APPLICATION FOR FULL PLANNING PERMISSION

Application No: 01/00330/FUL

Proposal: Two storey side extension, single storey rear conservatory extension and loft conversion with front dormer window.

At: 34 Clevedon Road Tilehurst Reading

CRT/P01 'A'

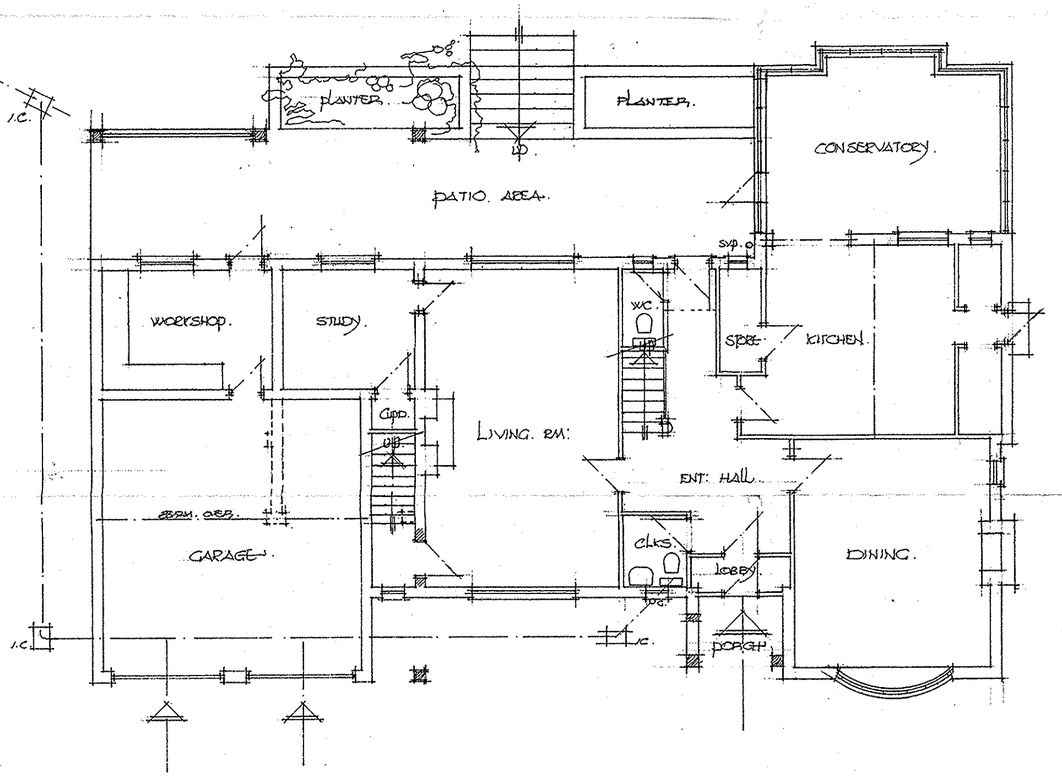
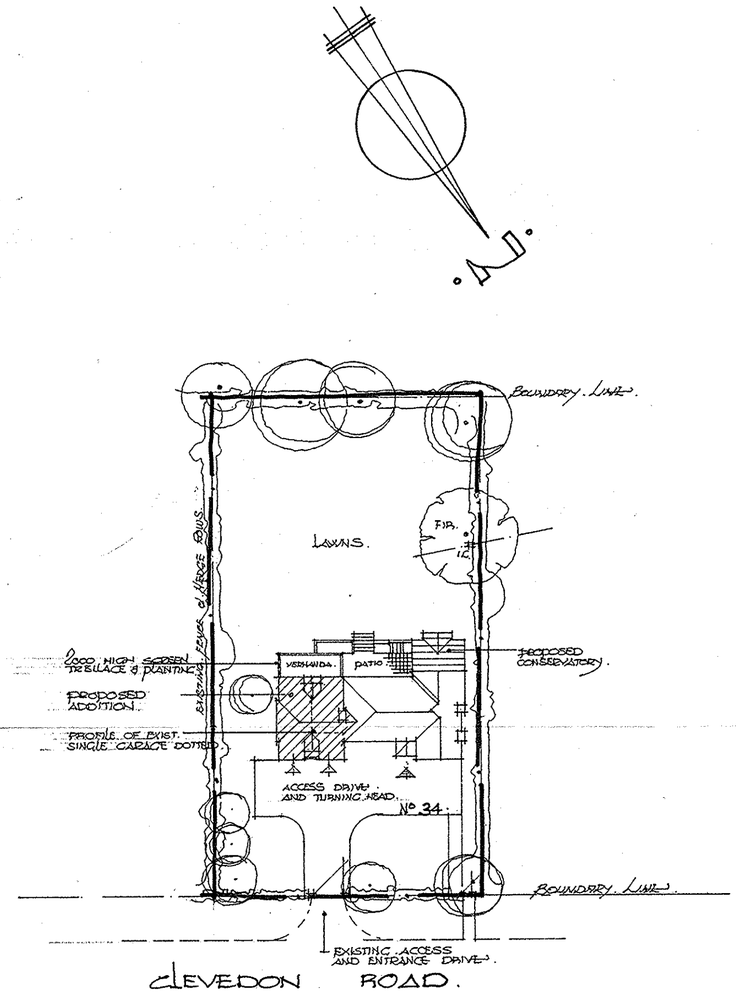
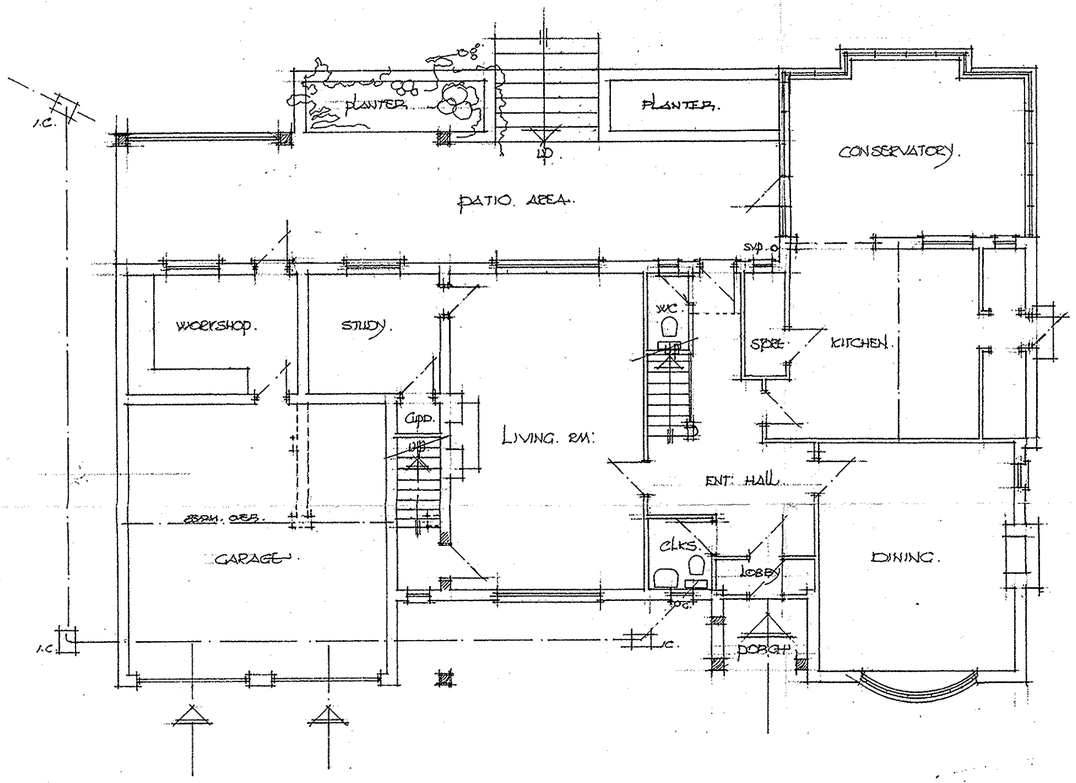
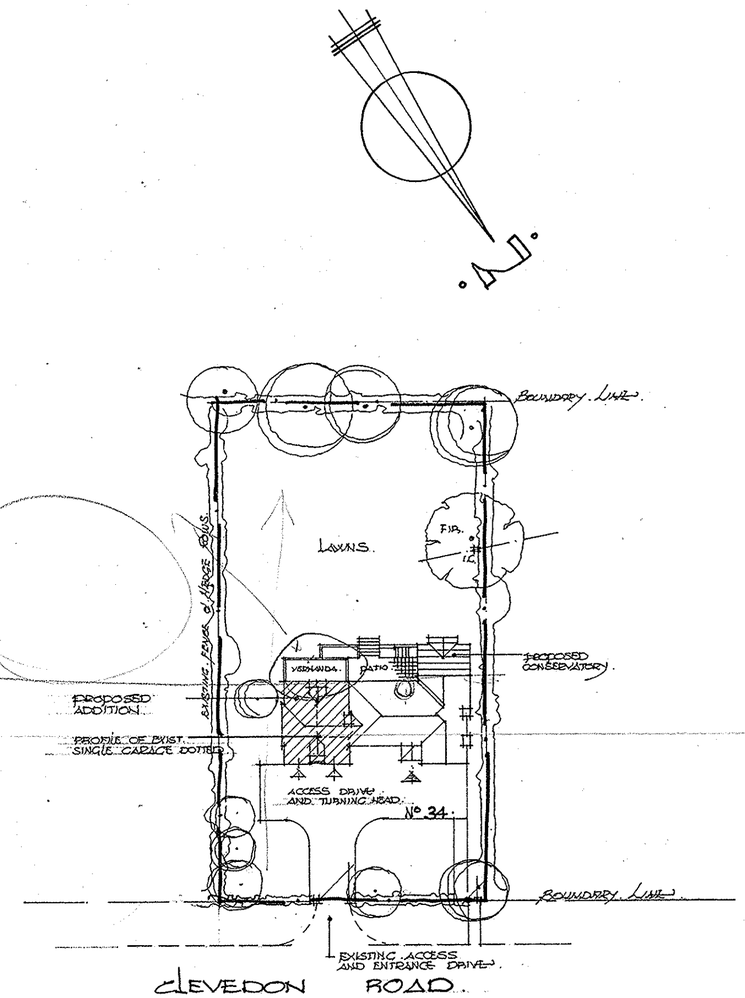
A rear verandah is however proposed at first floor level above a ground floor patio (extends existing patio), which projects about 2.5m from the rear of the house, and is some 7.5m wide. If there is to be any overlooking or loss of privacy from the extended number 34 to its neighbours, it will be from this point. **For this reason**

therefore, I requested amended plans to show a "fence" on the side of the verandah facing number 9. The applicant was happy to provide this. This should be secured by condition. However (and in addition) the alignment of the properties, the distances involved and the presence of boundary vegetation will mitigate any such effects of the proposals.

A. JUNE. 2001. SCREEN. TO BALCONY ADDED FOR. PLANNING. REQUIREMENTS.

REVISIONS.		C.R.T/P03.'A'
'A' JUNE. 2001. 1.000 HIGH TRELLAGE SCREEN TO BALCONY AREA ADDED AT PLANNING REQUEST.	CLIENT: MR. & MRS: R. JENKINS.	SCALE 1:100 · DATE · MARCH 01. · DRAWN. JRP.
	DRAWING. ◦ELEVATIONS◦	PROPOSED ADDITIONS TO Nº34 CLEVEDON ROAD TILEHURST READING BERKSHIRE.

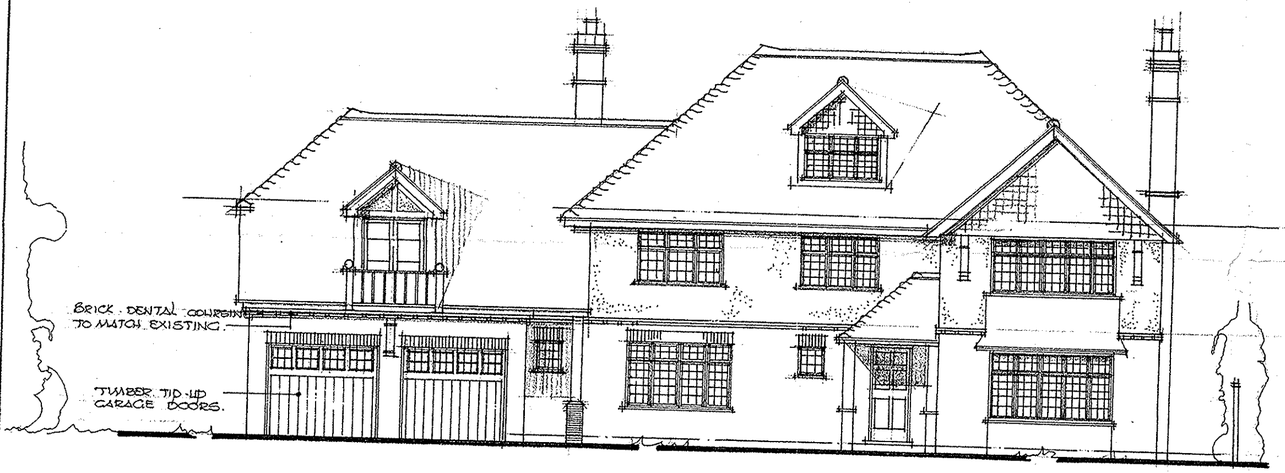
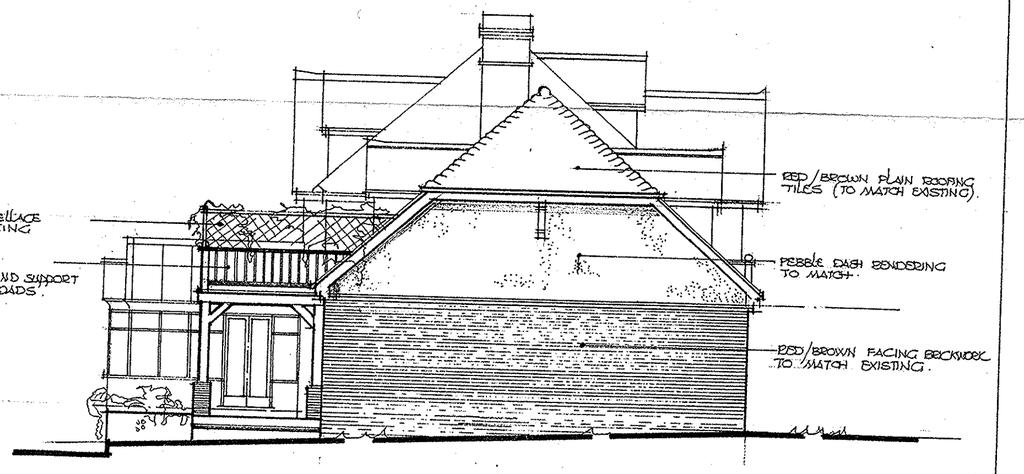
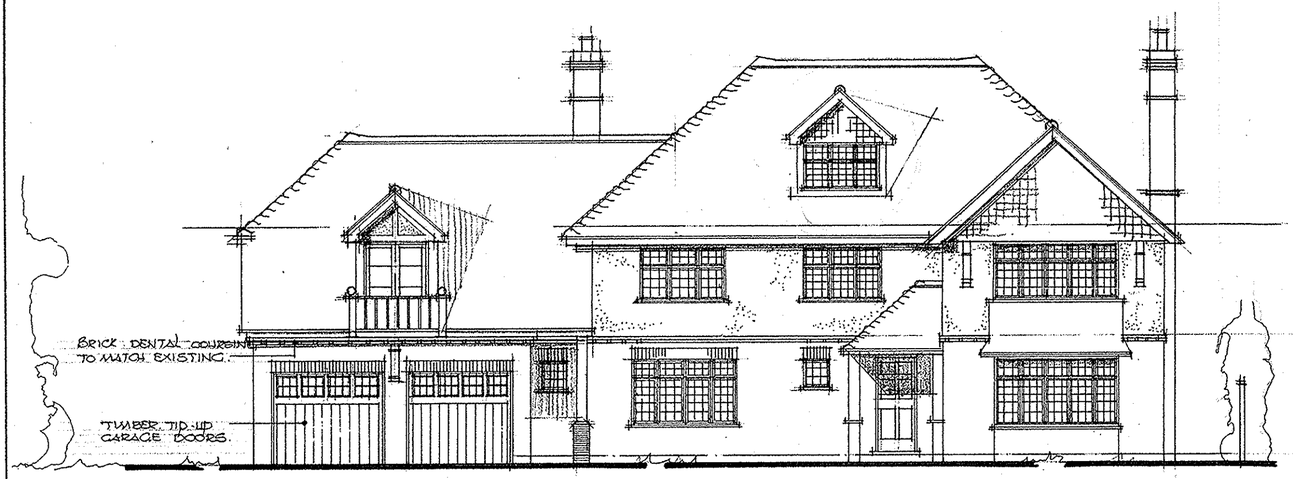
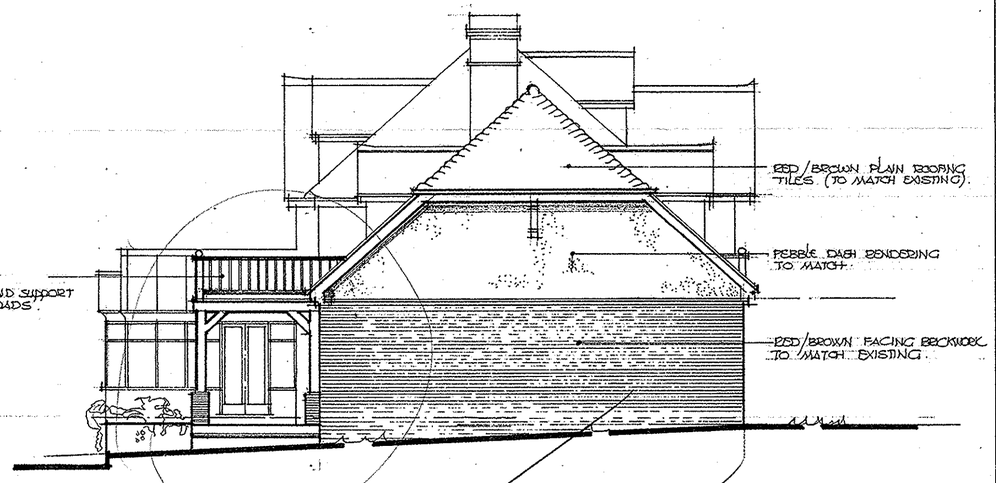
Neighbour objection received from number 9 Elsley Road. This objects to the south facing dormer at second storey level as it infringes the privacy of their main garden, sitting room and principal bedroom. Furthermore, dormers at second floor level overlooking Clevedon Road have never been inserted in existing houses, and would thus set an unsuitable precedent in this residential neighbourhood both in appearance and causing problems of privacy. There is no objection to velux type windows.

Response: Number 9 Elsley Road is situated on the opposite side of Clevedon Road to the application property. The nearest building to building distances involved, across Clevedon Road, are generous. The application property is set some 19m back from its front boundary, Clevedon Road is about 12m wide; and the property directly opposite is set some 23m back from its front boundary - a total of some 54m. The nearest corner of the garden of Number 9 Elsley Road is some 40m away, and the house itself is some 77m away. These distances "speak for themselves" (without even taking into account levels and intervening vegetation).

Clevedon Road (and surrounding roads) does (do) not follow any pattern of house styles. The design and scale of properties varies considerably. Whilst second floor dormers are not apparent in the immediate area, at least three nearby properties contain first floor dormers (numbers 21, 29 and 33), and at least one property contains three floors (number 25). Furthermore the insertion of dormers in the second floor of of the application property does not increase the height or overall plane of the roof of the property. The dormers are well designed and are set into the roof as required by this Council's Development Control Guidance Note on House Extensions.
